Technical Note: No 1a	Date: 28/06/2024
Project No: t24.134	
Project: Victoria Park Christian School	
Subject: Addressing the Town of Victoria Park comments

Figure 2: Proposed new carpark

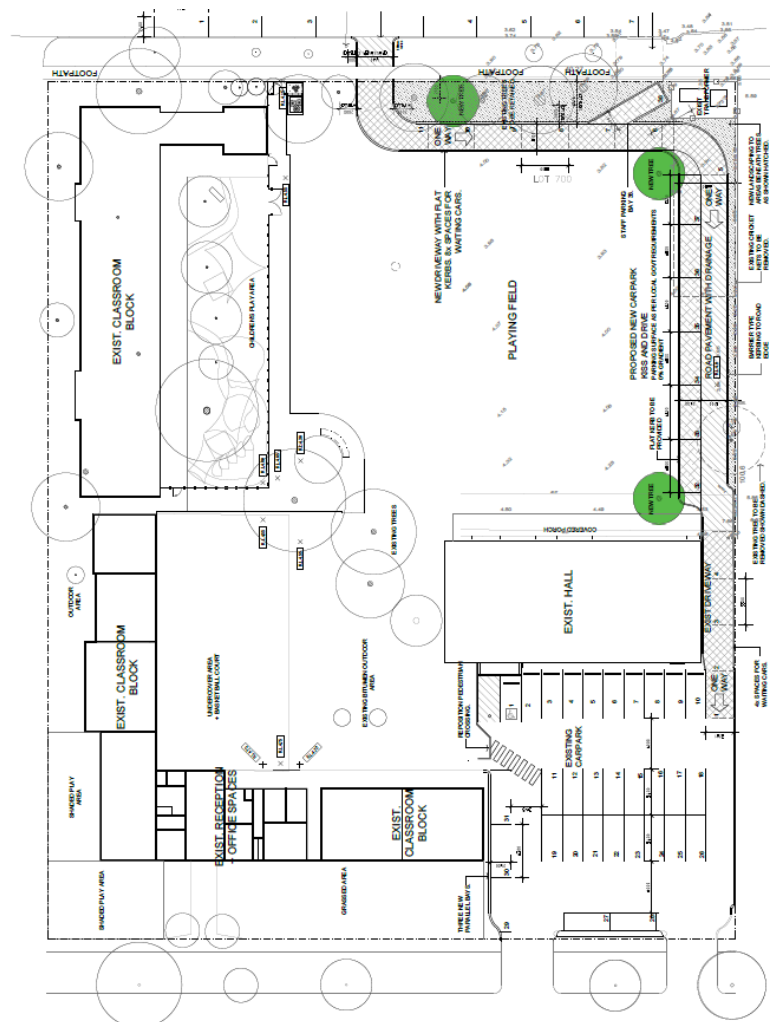
4. PARKING SUPPLY AND DEMAND

The Town of Victoria Park requires car parking for private schools to be provided at a minimum rate of 14 bays per 100 students, plus staff car parking at a rate of 0.07 bays per student or 7 bays per 100 students. Based on a maximum capacity of 250 students, the Town's parking requirement is therefore 18 bays for staff and 35 bays for students which equates to total parking demand of 53 bays.

The proposed new car park will provide a total of 38 bays on site (excluding the 11 stacking bays) which results in a 15-bay shortfall against the Town's car parking requirement ($53 - 38 = 15$).

It is suggested that 15 bays out of the 31 on site bays (1-31 on the site plan) should be allocated to the visitors (mainly kindy and pre-primary) and the balance 16 bays should be allocated for the staff. The proposed parking provision of 38 bays, with the suggested allocation, is estimated to meet the actual parking demand of 37 bays for the future enrolment of 250 students.

32 Oswald Street, Victoria Park
 Austrorads 2013: B99 Passenger Car
 New Driveway Entry and Exit

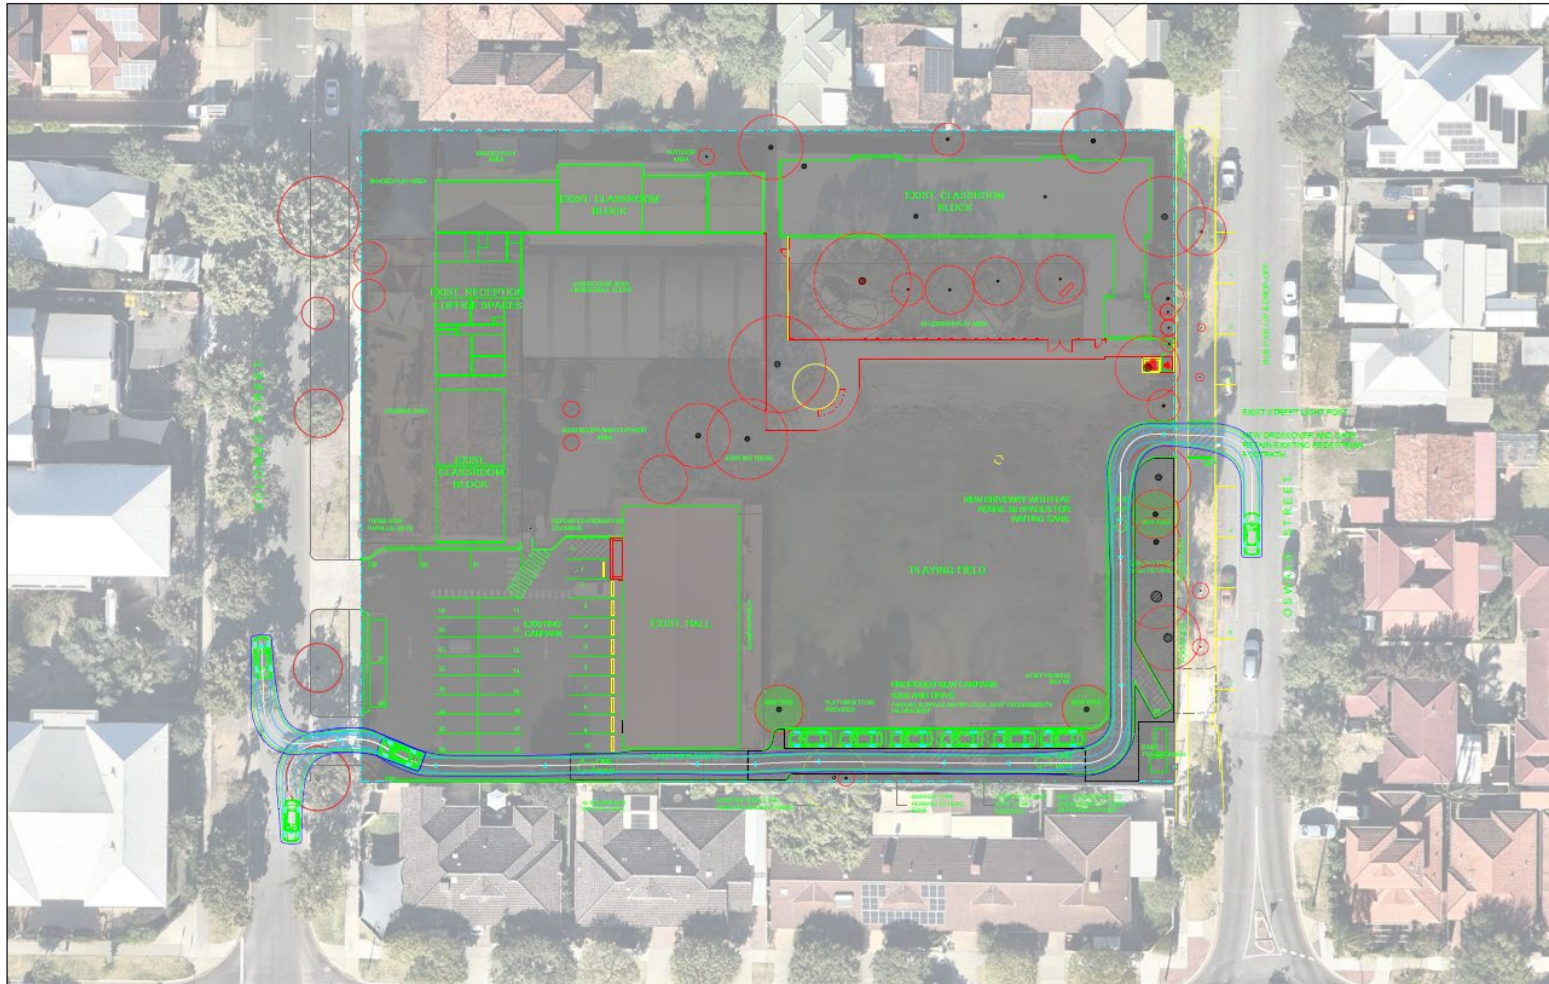
12. UPDATED SWEPT PATHS FOR B99 PASSENGER CARS

The swept paths for B99 vehicles accessing and egressing the proposed new parking bays are presented in **Appendix C** which confirm satisfactory traffic operations.

Extra space is provided in front of bay 32 (first kiss and ride bay) to ensure the B99 vehicle parking on this bay can exit the bay without impacting the existing verandah. The area behind Bay 37 (last kiss and ride bay) would be painted to allow for B99 vehicles to park in forward gear.
